DOCKETED	
Docket Number:	23-IEPR-03
Project Title:	Electricity and Gas Demand Forecast
TN #:	254466
Document Title:	San Diego Gas & Electric Comments on the 2023-2040 California Energy Demand Forecast
Description:	N/A
Filer:	System
Organization:	San Diego Gas & Electric (SDG&E)
Submitter Role:	Public
Submission Date:	2/14/2024 4:44:25 PM
Docketed Date:	2/14/2024

SDG&E Comments on the 2023-2040 California Energy Demand Forecast

**SUBJECT: San Diego Gas & Electric Company (SDG&E) Comments on
2023-2040 California Energy Demand Forecast**

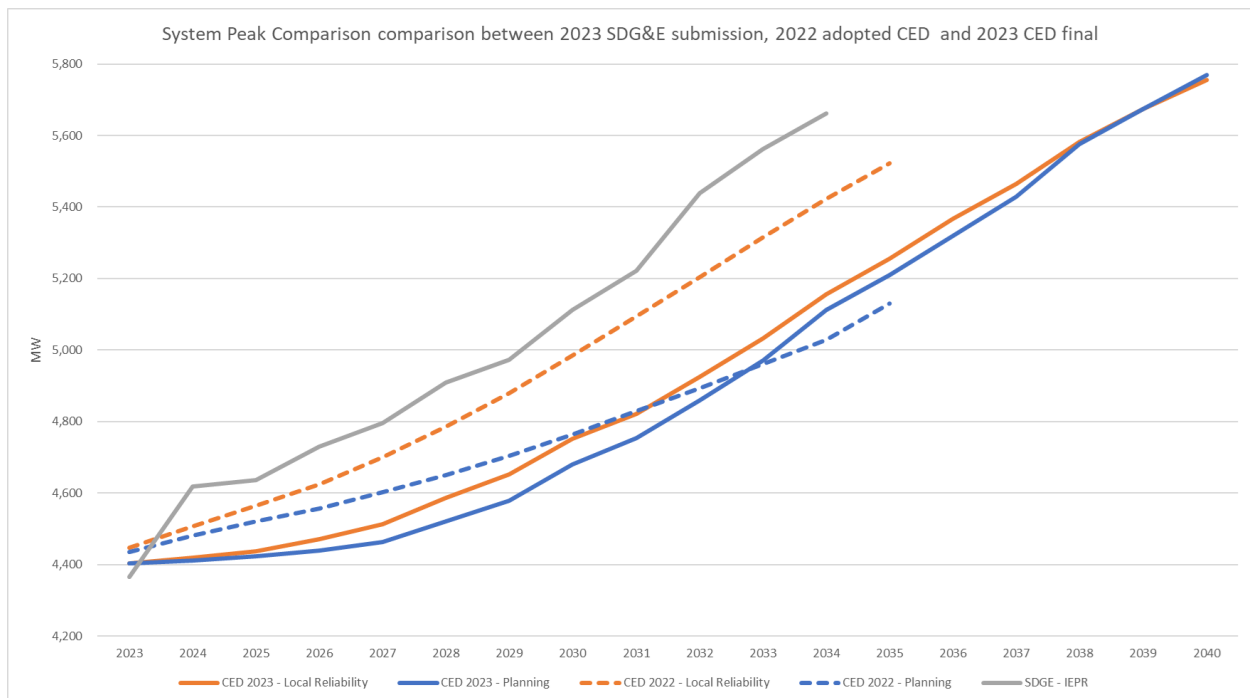
I. The 2023 CED Forecast is significantly lower than SDG&E’s anticipated peak load and energy sales forecasts.

The disparity between SDG&E’s submitted 2023 forecast and the CEC’s 2023 CED Forecast varies on a year-to-year basis, but reaches up to approximately 500 megawatts of system peak demand in the later years, as shown in the chart below.¹ This is equivalent to up to 10% of SDG&E’s peak load.

SDG&E highlights this disparity to underscore the need for continued evaluation and discussion with stakeholders to ensure that the forecast is well understood and does not unintentionally impact our collective ability to equitably achieve state climate and clean energy goals.
